AMENDMENT UNDER 37 C.F.R. § 1.111  
Application No.: 09/732,712  
Atty Docket No.: Q57601

**REMARKS**

**AMENDMENTS TO THE DRAWINGS**

Fig. 1

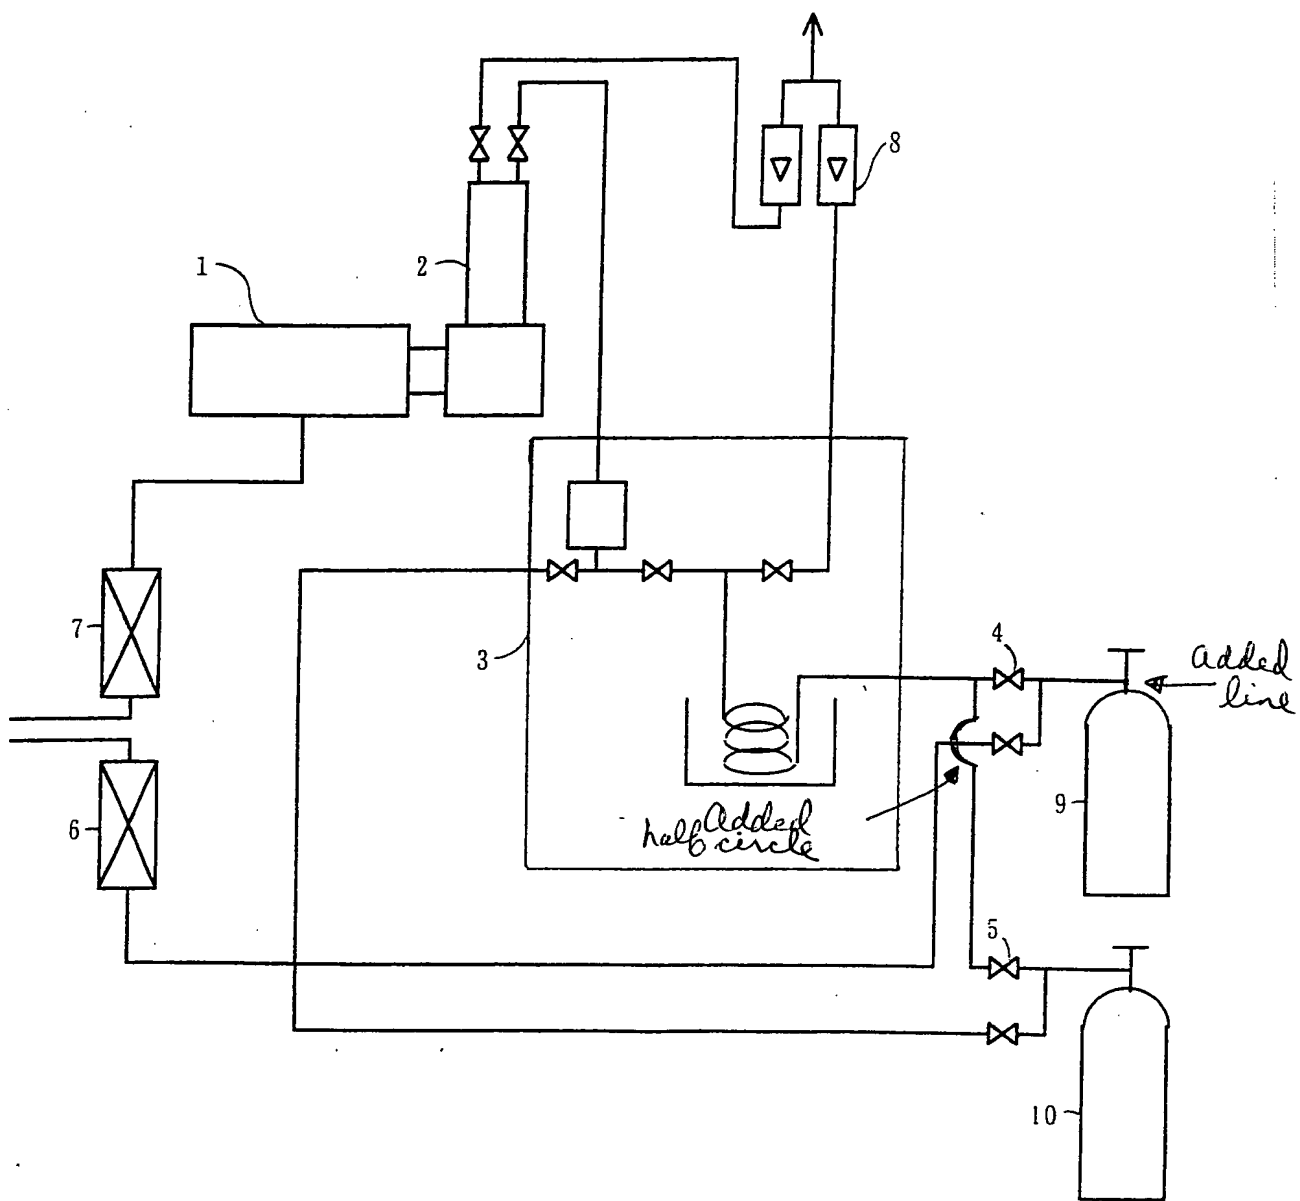
First, the Examiner is arguing that the drawings do not clearly show an apparatus in which liquefied ammonia is withdrawn from the measurement sample cylinder 9, and only show an apparatus in which a gaseous phase moiety of liquefied ammonia is withdrawn from the measurement sample cylinder 9.

The Examiner states that to differentiate between the liquefied ammonia and the gaseous phase moiety of the liquefied ammonia, a pipe, which is inserted in the liquefied ammonia in the tank (measurement sample cylinder 9) and used to withdraw the liquefied ammonia from the tank to the heater, should be shown in Fig. 1. The Examiner states that otherwise, Fig. 1 shows

two identical tanks with pipes for withdrawing gaseous phase moiety of the liquefied ammonia, with one of the pipes being heated.

Applicants note that in Fig. 1, there is a space between connecting line 4 and measurement cylinder 9 at the point where these two members attach to each other. This space should not exist and it was the intention that connecting line 4 is attached to cylinder 9 in the same way as shown for connecting line 5 being attached to reference gas cylinder 10. Applicants enclose a replacement sheet of drawings to correct Figure 1 on this point, as well as an annotated sheet of drawings showing the correction in red.

Further, in Fig. 1, connecting line 5 contains a vertical portion where it connects to connecting line 4. The drawing, however, shows a gap in this vertical portion. This gap was not intended. Applicants have drawn a half circle to connect these lines as a correction, and show this correction in red on the annotated sheet.

With respect to the first reason for the Examiner's objections to the drawings and Fig. 1, applicants submit that the present Fig. 1 would be understood by one of ordinary skill in the art to be sufficient to illustrate a process in which liquefied ammonia is withdrawn from measurement sample cylinder 9 and introduced into the vaporization unit 3.

The measurement sample gas container 9 may have any structure as far as liquefied ammonia can be taken out from the container. Such structures are well known in the art. Applicants enclose herewith a sketch of new proposed Figure 5 which illustrates an example of such a well known structure. Fig. 5 illustrates the inside of the container 9. In Fig. 5, the dipping tube 50 of the container enables liquefied ammonia to be withdrawn from the interior of the container. Upon approval of Fig. 5, applicants will amend the specification as follows:

Please replace Figure 1 with the amended Figure 1 shown in the attached replacement sheet. The amendments to Figure 1 are explained in the Remarks.
